ADDENDUM NO. 1

Date Issued: November 1, 2013
To: All Bidders
Project Name: Capital Area Transportation Authority
New Lighting & Fencing
Project Number: 0941.6302.00
ITB Number: 2013-127
Subject: This Addendum is issued to clarify and revise the construction documents dated August 15, 2013 as follows:

SHEET	5
OF	6
DRAWING NUMBER	E1.0

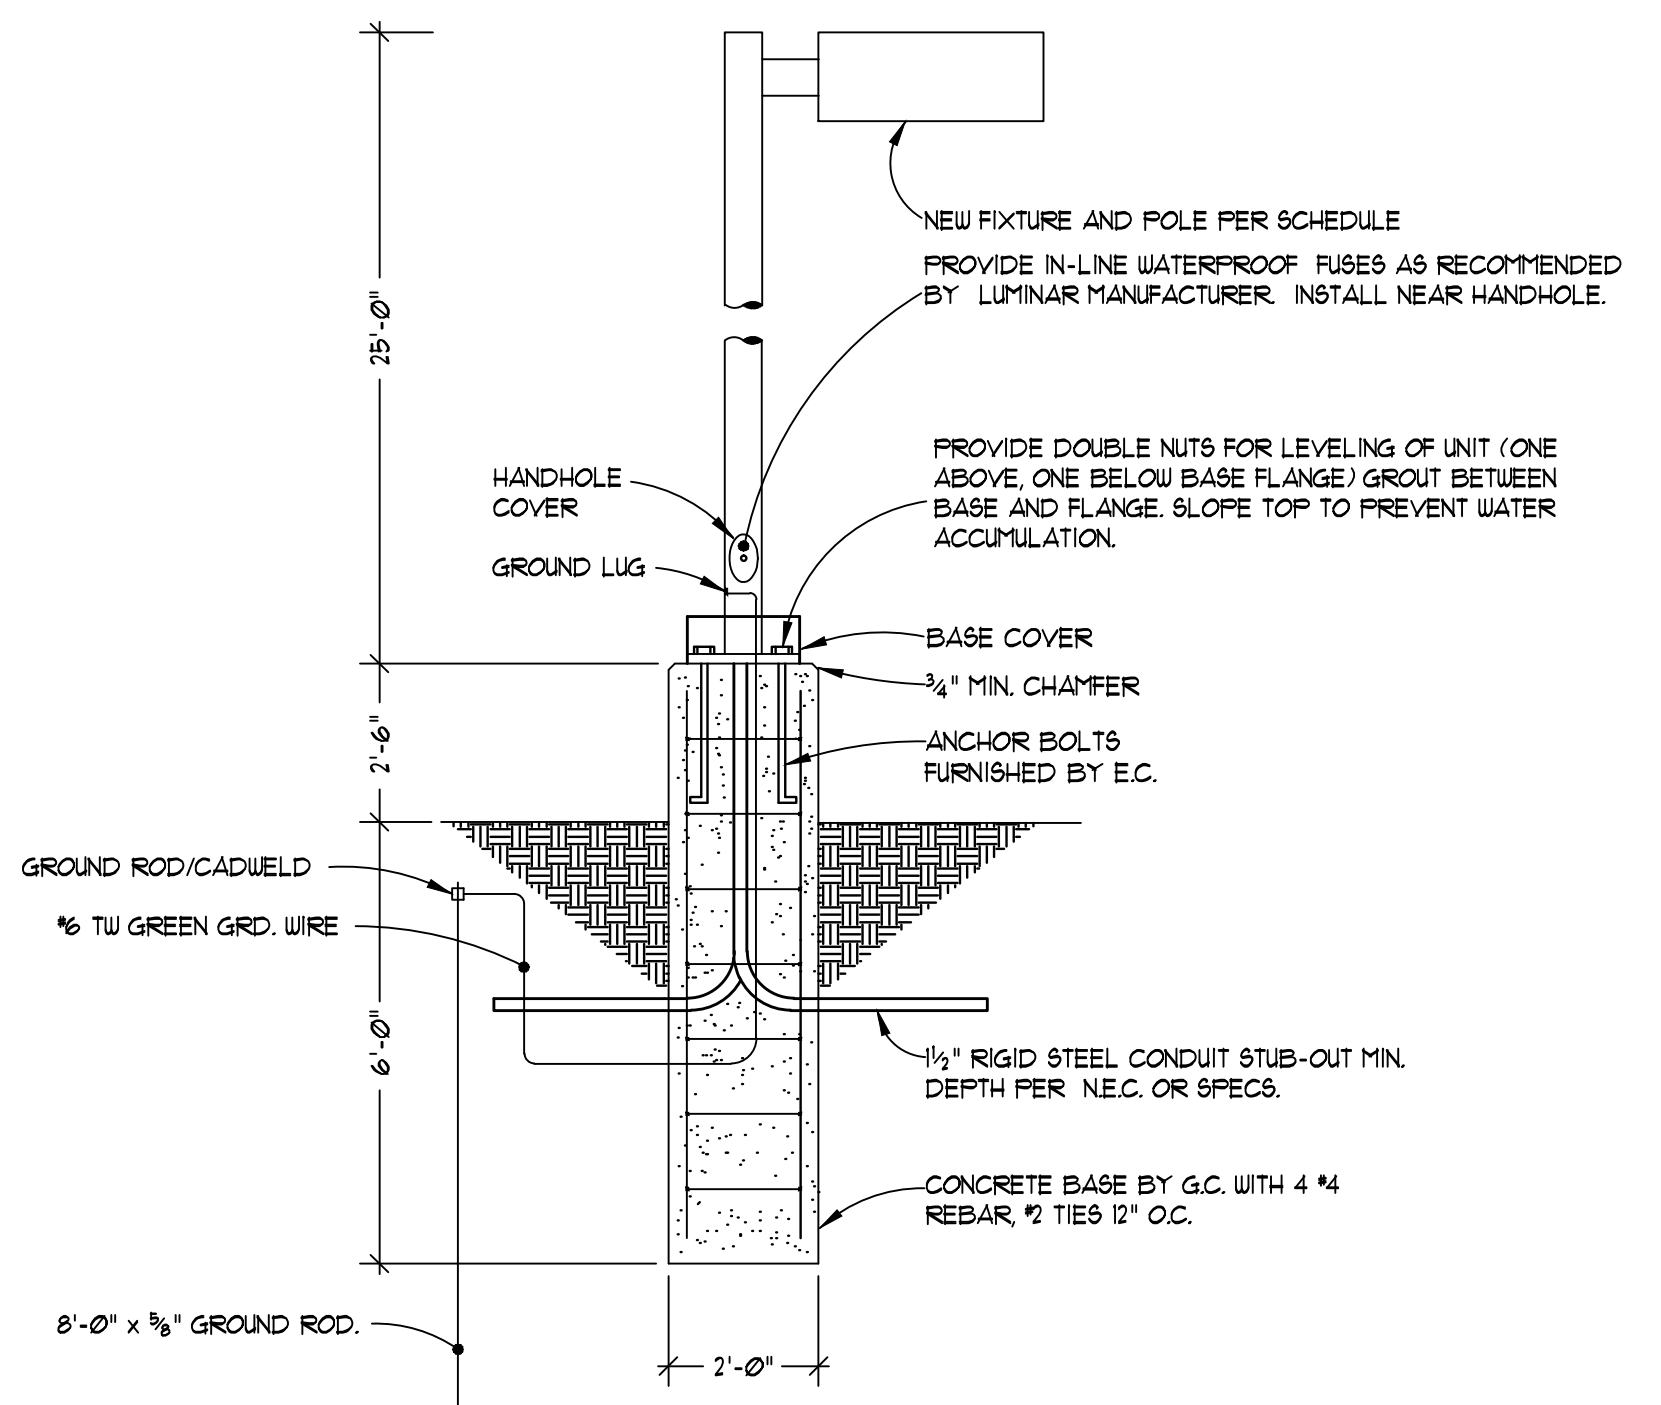
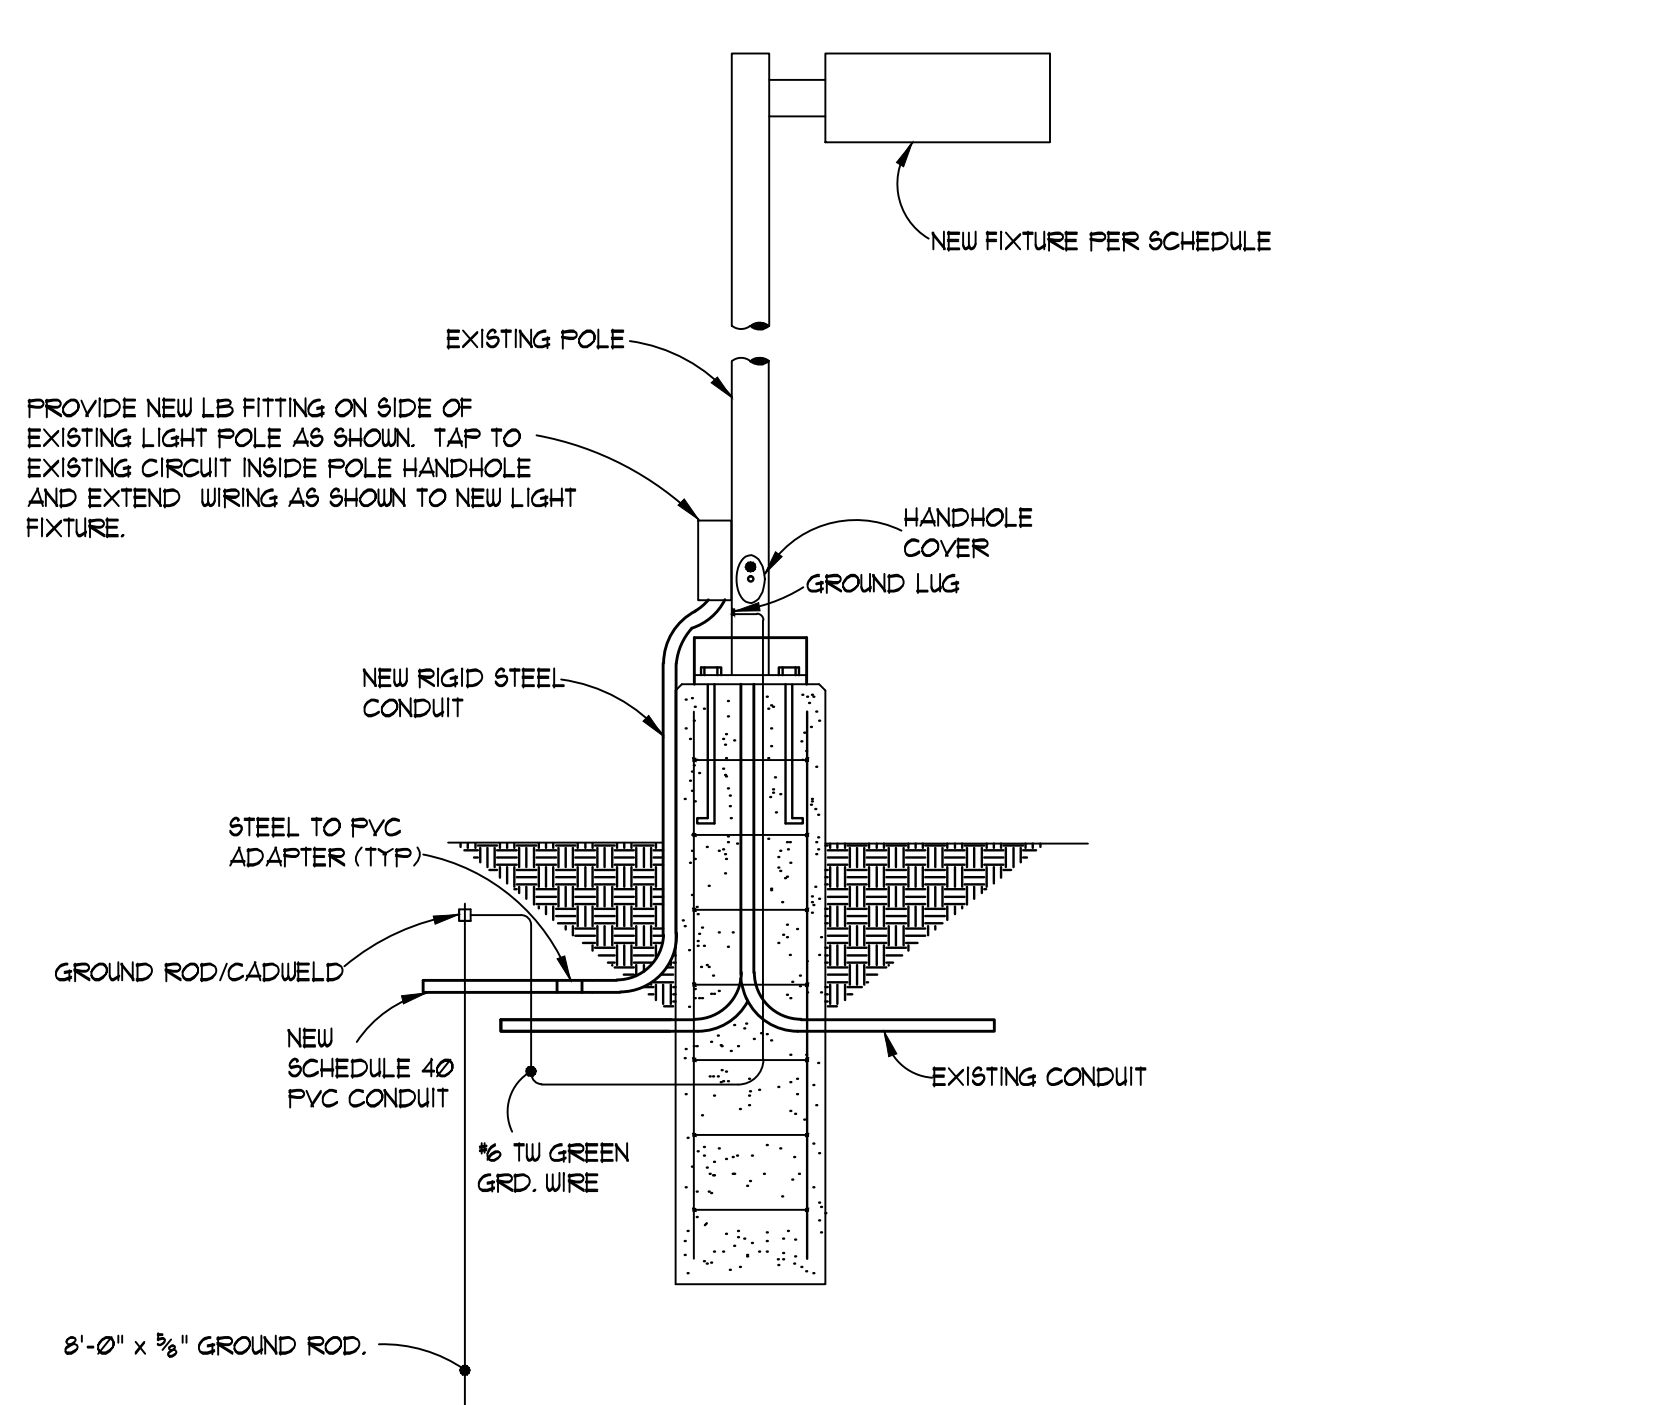
Item 1 – Sheet E1.0 (Reissued): Lighting Fixtures – HA & HB and Light Pole HB have been deleted in correlation with clarifying the bidding requirements.
